ErSed Reference: 21003-YARDS-LTR-210813

Re: SSD-9522: Kemps Creek Warehouse, Logistics and Industrial Facilities Hub (the Yards)

Changes between CO13362.02.-EW201 and CO13362.02.-C201B

**EROSION AND SEDIMENT
CONTROL PLAN
STAGE 1 INTERIM PLAN**

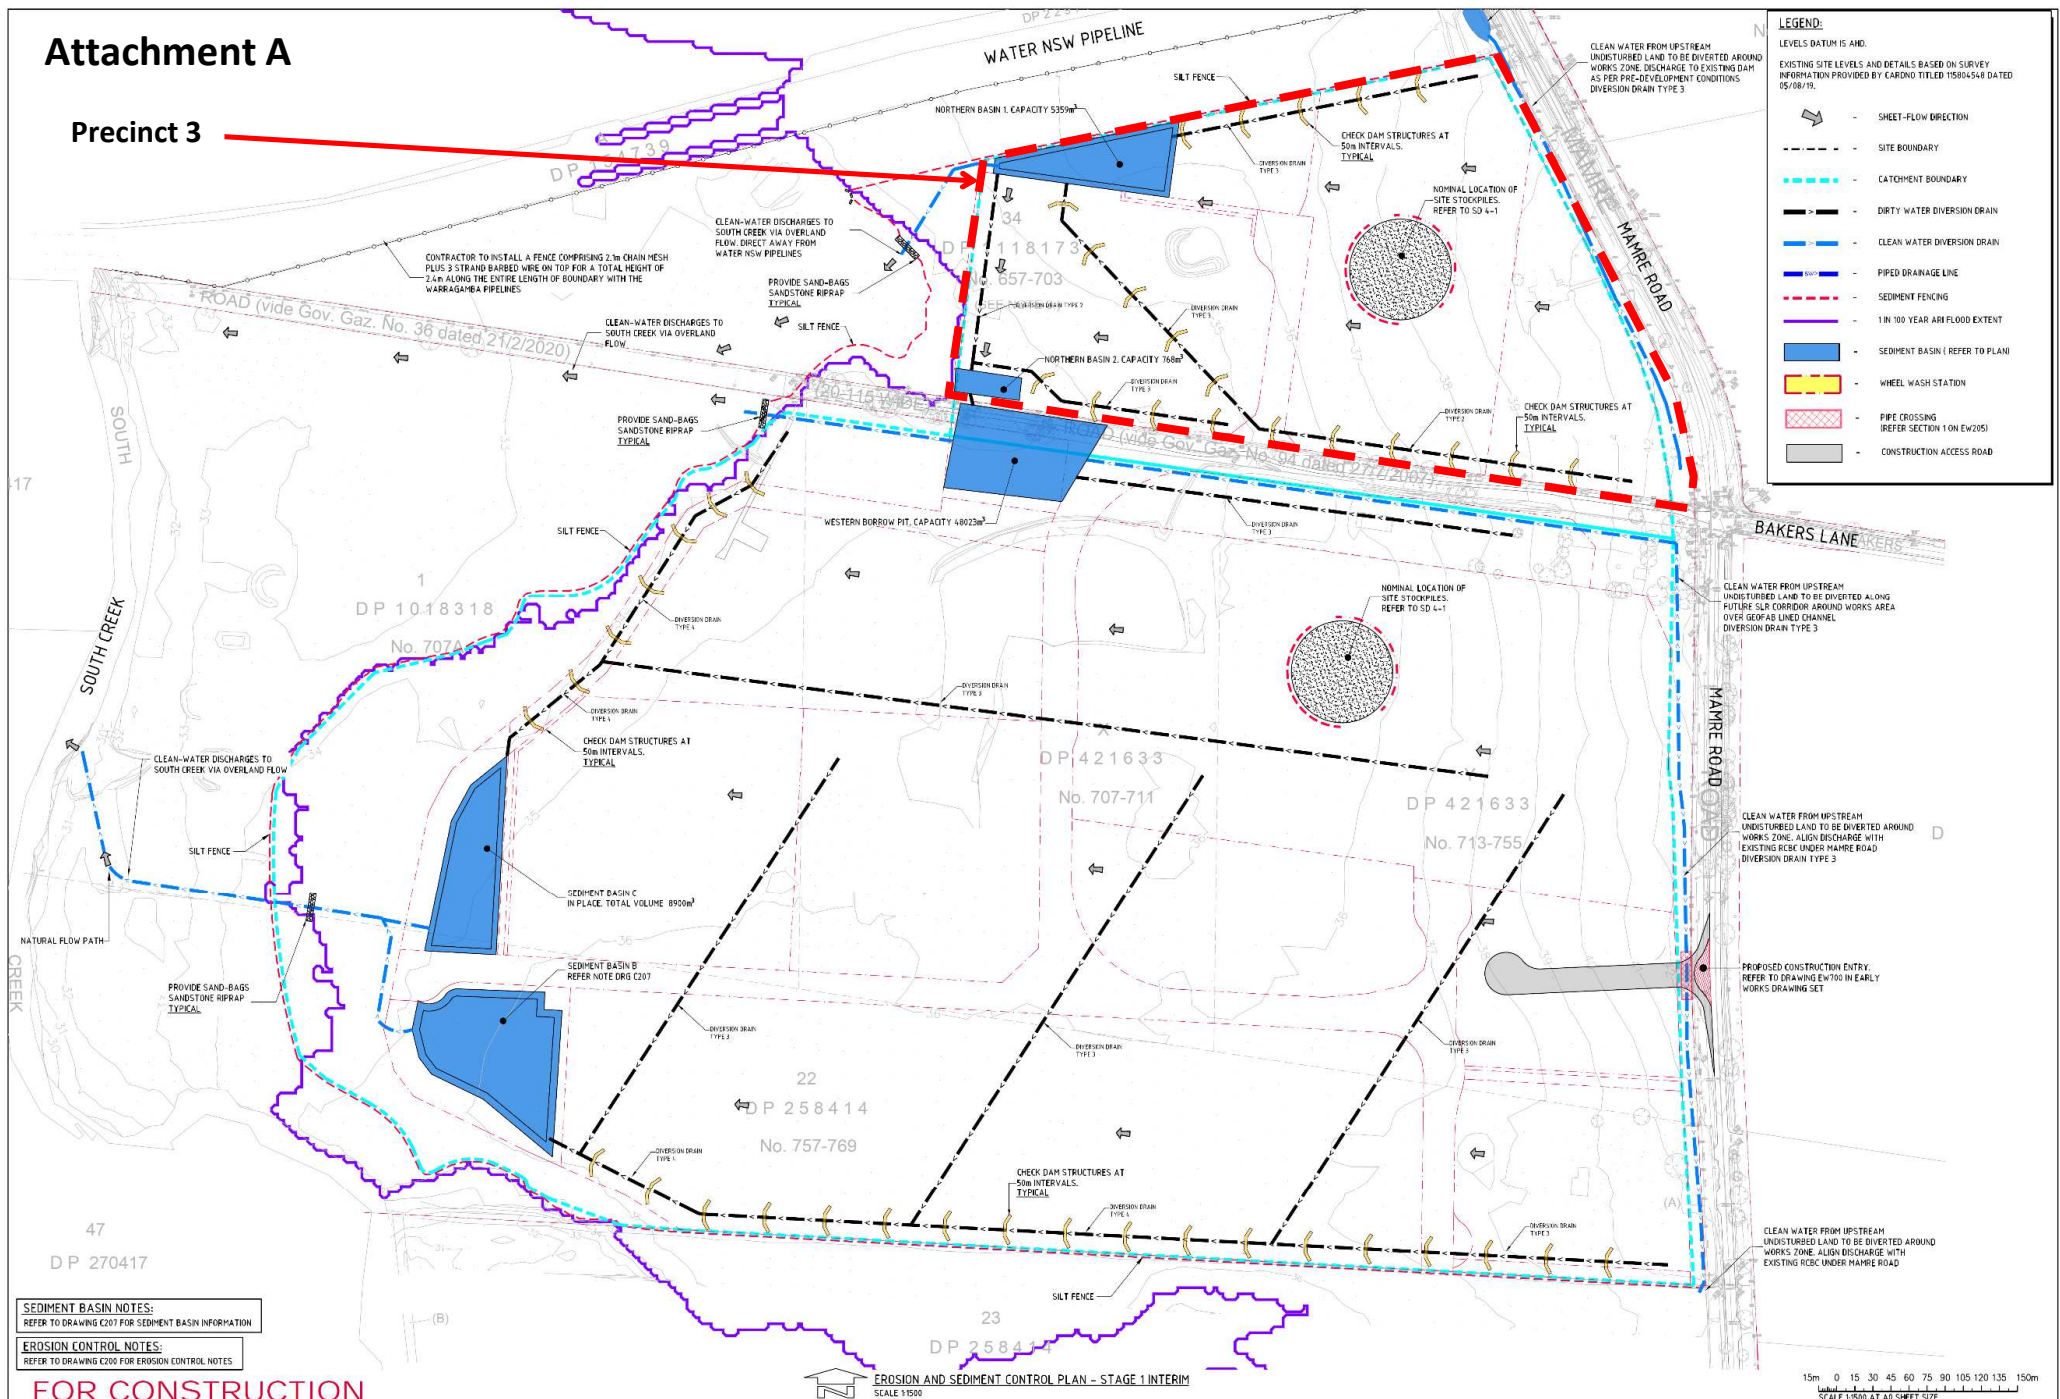
1. EW201 provides a single sediment basin for Precinct 3 (Basin A). This basin is shown to overflow essentially westward along the development boundary and offset from the WNSW Pipeline.

C201B provides an outlet from Basin A which is slightly modified to flow to the Southwest. This has been changed due to the current saturated ground conditions west of the basin and to reduce potential for the additional flows to flood and pass to the north and towards the WNSW Pipeline.

2. EW201 provides a single sediment basin for Precinct 3 (Basin A with volume required of 3797m³).

At time of constructing Basin A, wet site conditions and existing levels meant that the entirety of Precinct 3 could not be made to report to the single Basin A as indicated in EW201.

Accordingly, a second basin (Basin C) has been constructed in the Southwest corner of Precinct 3 to accommodate that portion of the precinct which could not be made to report to Basin A. The reporting catchment has been indicated as 2.64HA leading to a required volume of calculated required volume for 591m³.

3. The additional Basin C overflows to the existing western borrow pit located immediately south of Bakers Lane and Precinct 3. The available volume of this borrow pit has been as 48,000m³ (compared to ~770m³ of Basin C).

This is to, as far as practical, avoid possible noncompliance with Condition B26 of SSD-9522 which requires that stormwater is not to be directed towards the WSNW Warragamba Pipeline.

This modification does not reduce or negatively affect the intended function of Basin A as indicated within EW201.

Basin A has been constructed with a confirmed volume 5359m³. This exceeds/complies with the volume indicated within the EW201.

Basin C has been constructed with a confirmed volume of 768m³. This exceeds/complies with the volume indicated in C201B.

An equivalent or greater volume is provided within the sediment basins detailed within C201B as that detailed within EW201. These basins have been sized using the same criteria and in accordance with the approved CEMP.

This modification does not reduce or negatively affect the intended function of the primary sediment control basin as indicated within EW201.

When required, the borrow pit is treated and dewatered directly or managed to the other main basins for treatment and dewatering in accordance with best practice.

It has been confirmed with site management that this additional storage, or otherwise a stable outlet from basin C, is to be maintained until outlet from Basin C is no longer required and the entirety of Precinct 3 is made to report to Basin A as indicated in EW201.

This modification does not reduce or negatively affect the intended function of the primary sediment controls as indicated within the EW201 and the approved CEMP.
